Applicant : Gordon W. Breuker et al.
Appln. No. : 10/600,777
Page : 18

REMARKS

Application No. 10/600,777
Amendment dated August 18, 2005
Reply to Office Action of May 18, 2005
Annotated Sheet
Showing Changes

FIG. 5

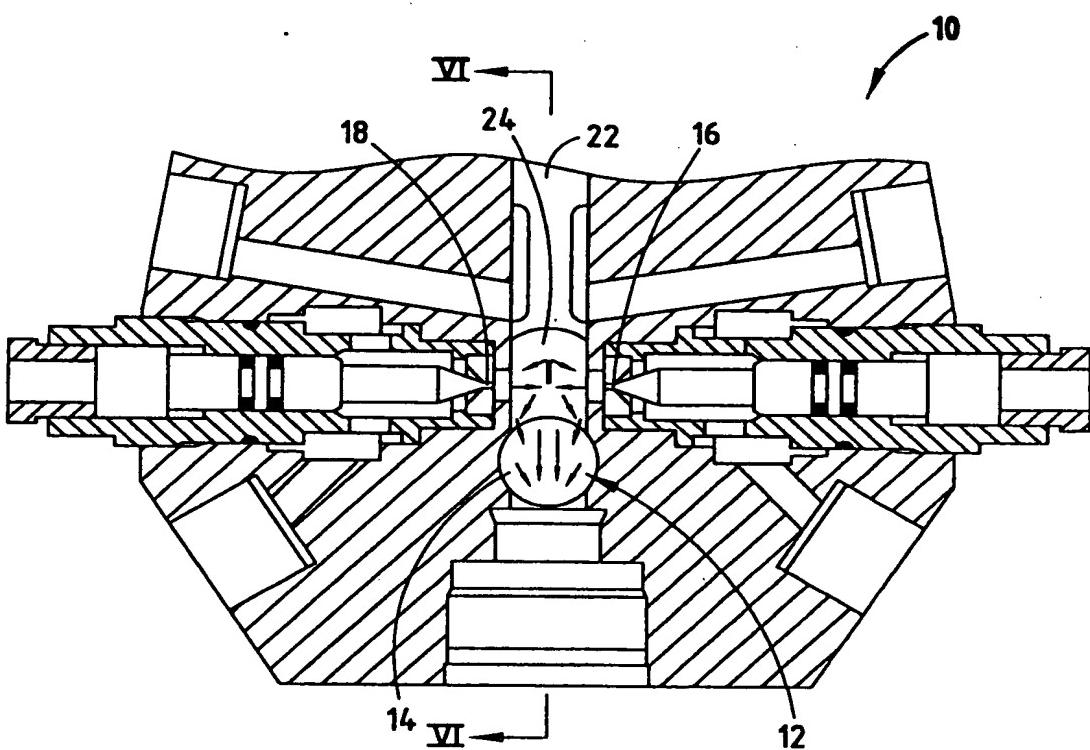
The drawings have been objected to for not containing the legend "Prior Art" in Figs. 5-7. Applicants have added the legend "Prior Art" to Figs. 5-7 and submit that the objection to the drawings is now obviated.

Prior Art
legend added
